EXHIBIT 8

**POLARIS****TECHNICAL SERVICE BULLETIN**

Bulletin Number: A-17-01-B

SUBJECT:**2016 Sportsman 850/1000 High Lifter Edition Thermal Protection Update****PURPOSE:**

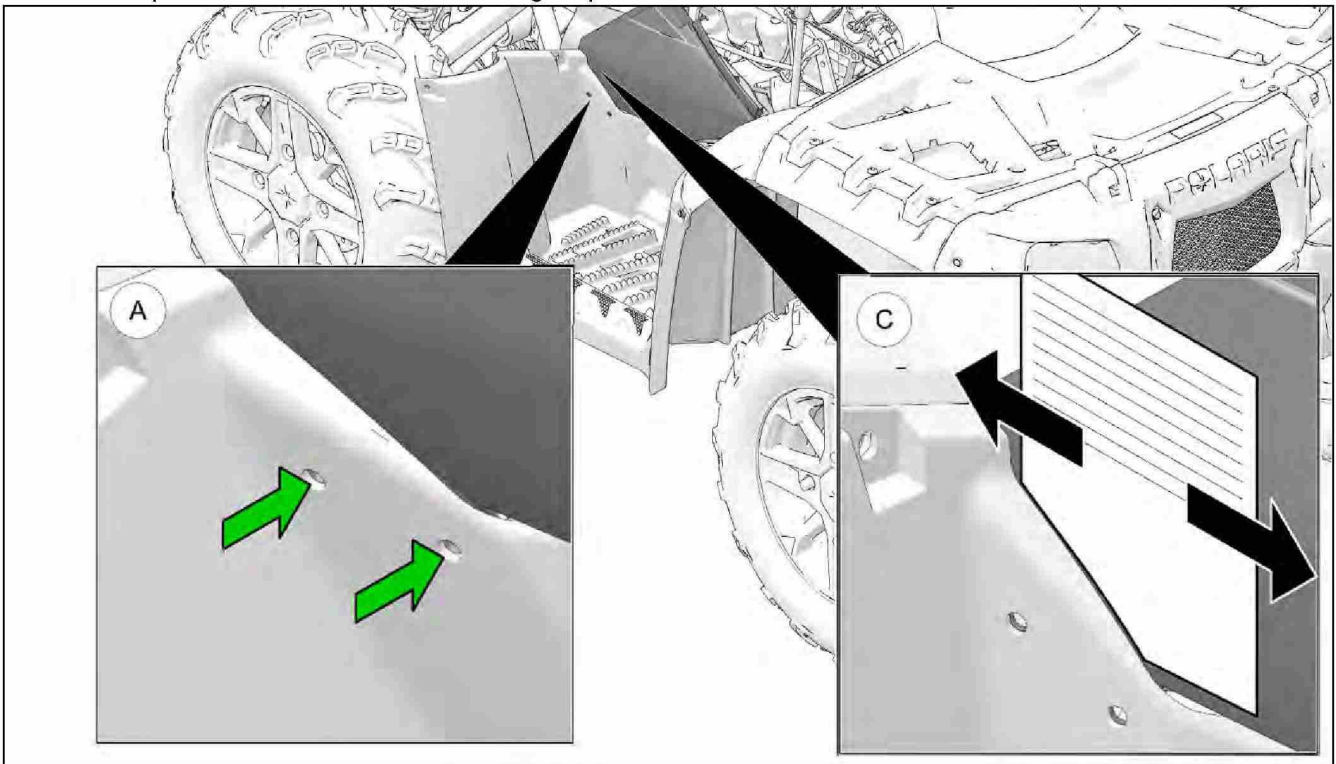
5. Using a DREMEL® with a two flute bit intended for plastics, a reciprocating saw or similar device, trim the footwell corner in line with the template (area circled in red shown in the **Before** and **After** images below).

Before

After

6. Test fit the new panel to verify the area trimmed area of the footwell does not contact the exhaust manifold side panel.
- Align the exhaust manifold side panel mounting holes.
 - Apply pressure to the footwell at the mounting holes.
 - Slide a piece of paper along the gap between the two panels.
 - If the paper slow or stops or the metal shield makes contact with the footwell, use a half-round file to trim the footwell to create a clearance gap between the components.
 - If the paper freely travels the length of the gap, and the metal shield does not contact the footwell, proceed to the audit and following steps.

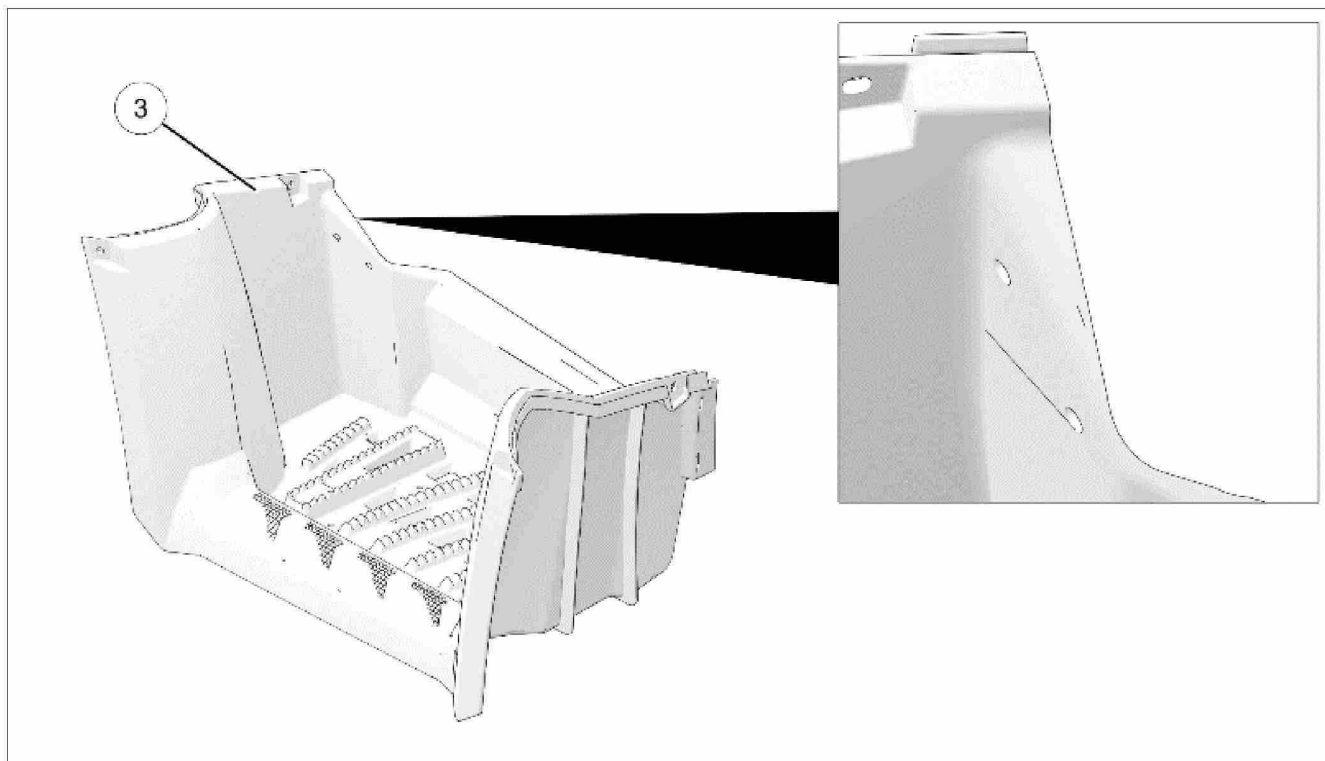
A secondary dealer representative must verify that the trimmed edge of the footwell does not contact the new exhaust manifold side panel.

If a piece of paper does not freely slide between the panels, continue to trim the panel using a half round file until the paper passes freely the entire length of the gap.

7. Using a half-round file, file and deburr the trimmed footwell ③. Ensure the footwell is clean, free of burrs, and maintains rider appeal. Verify trimmed area appears as shown in the illustration below.

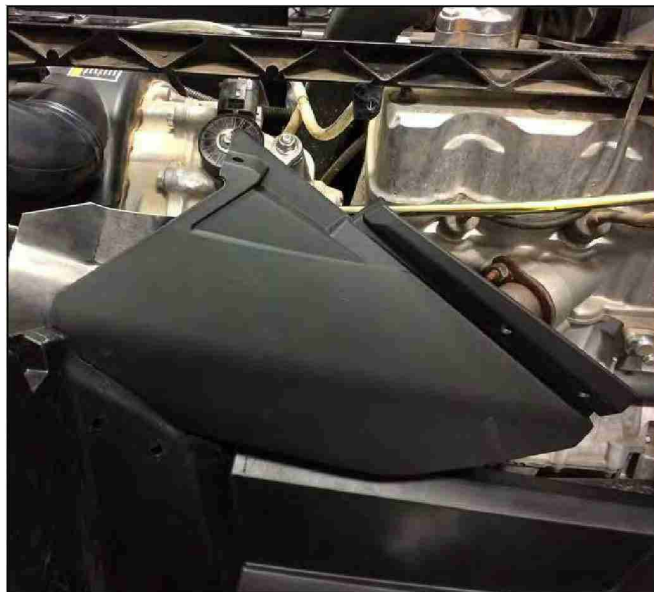
3. Pull the upper rear of the footwell towards the right side of the vehicle, then slide the NEW exhaust manifold side panel (2636626) along the head pipe and release the footwell.

A secondary dealer representative must verify the new exhaust manifold side panel (2636626) has been installed and the original exhaust manifold side panel has been discarded.

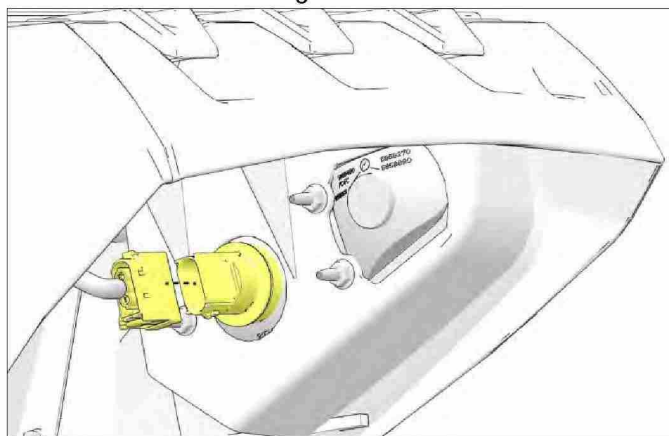
A secondary dealer representative must verify the Rear Cab Heat Shield is bent down and wraps around the corner of the Storage Box and Tail Light Harness. If it interferes when installing the cab, ensure it is bent back down to match the good example below.

Acceptable – Rear Cab Heat Shield wraps around the corner of the storage box and tail light harness

Unacceptable – Rear Cab Heat Shield interferes with the storage box and harness

PHOTO 1 - 850/1000 HIGH LIFTER - New Thermal Protection Foils

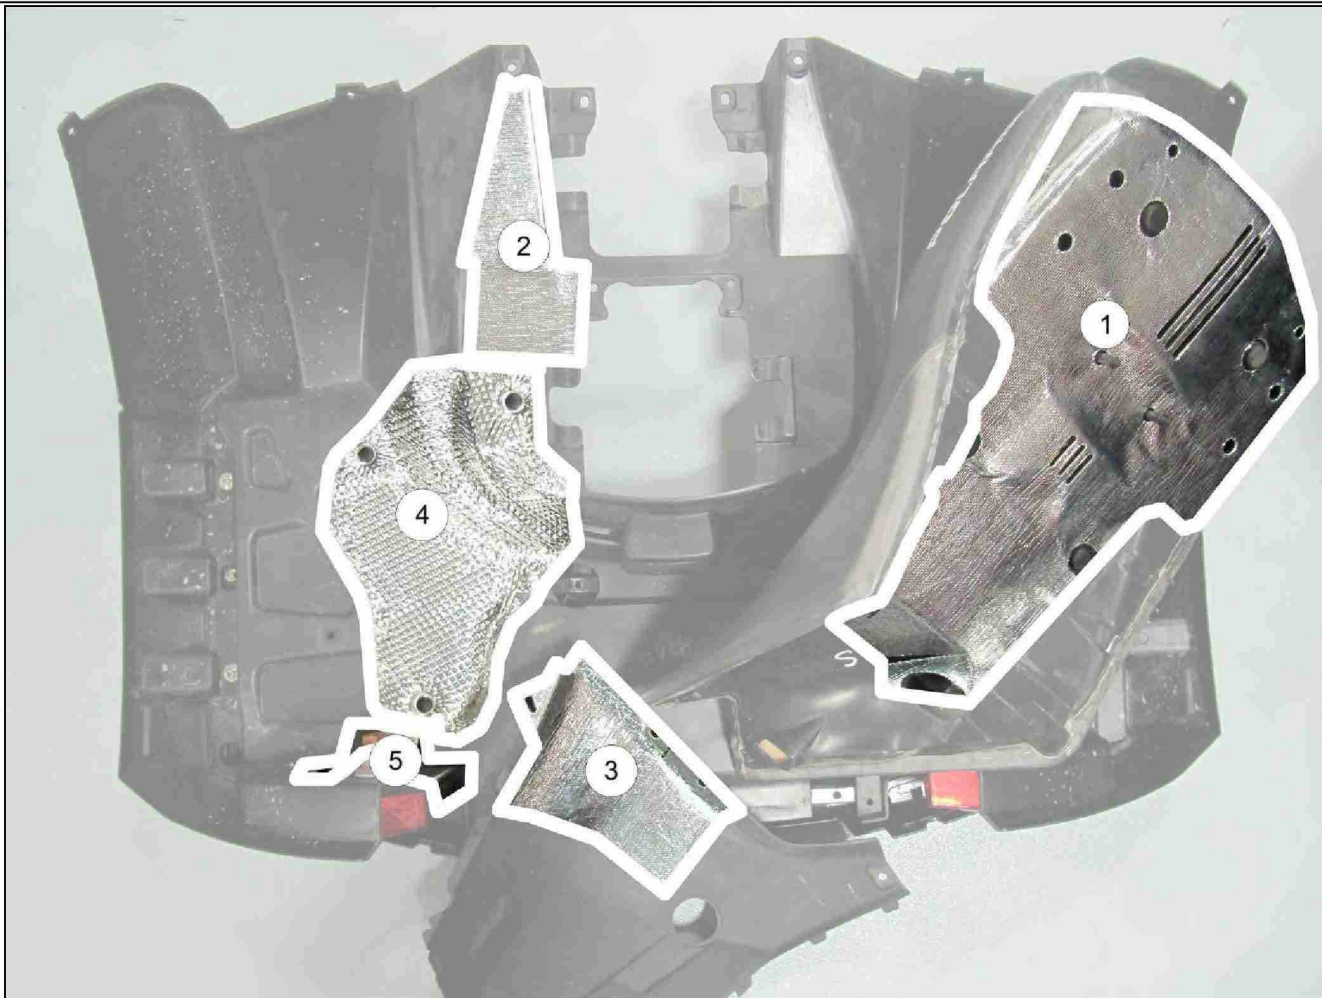
Two photos are required for warranty claim submission. A secondary dealer representative must verify both pictures to ensure proper final heat shield inspection. Examples of both images required are included on the following pages.
